Engineering Instruction

SUBJECT: LANDING GEAR - MAIN LANDING GEAR COMPLETE - INTRODUCTION OF A NEW CAP - <u>GROUP , CONFIG. 1</u>			
COMPLIANCE:			
SOURCE DOCUMENTS:		A/C CONFIGURATION (As per source document) GROUP , CONFIG. 1	
AIRCRAFT / ENGINE / COMPONENT EFFECTIVITY LIST			
A/C MSN	A/C Registration	Engine/Component Serial No	Engine/Component Part No
Concurrent Requirements:

Service Bulletin No. 10-355-32-29
Page 6

LH Main Landing Gear View from Outboard - Location of Modification
Figure 1

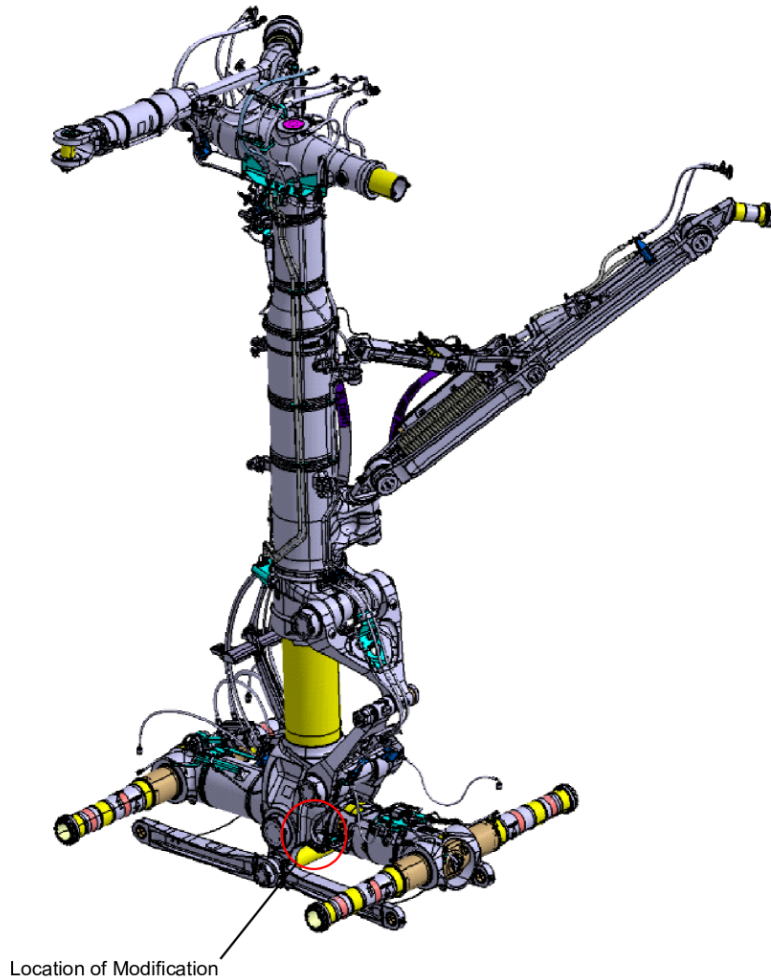
- Safran Landing Systems tells operators that a new cap is introduced to prevent contact between the 1M strut harness and a bolt in the location of the sliding piston fork. - Safran Landing Systems recommend that you do this Service Bulletin on main landing gears on which: - the strike number 10 has not been cancelled on the 10-357303 LH Series and 10-357403 RH Series shock strut dressings nameplate and looks like this 10 .			
©			
SAFRAN LANDING SYSTEMS 2019 (AND SUBSEQUENT REVISION PAGE DATES)			
This document and all information contained herein is the sole property of Safran Landing Systems (and/or its affiliated companies). No intellectual property rights are granted by the delivery of this document or the disclosure of its content. This document shall not be reproduced to a third party without the express written consent of Safran Landing Systems (and/or the appropriate affiliated company).
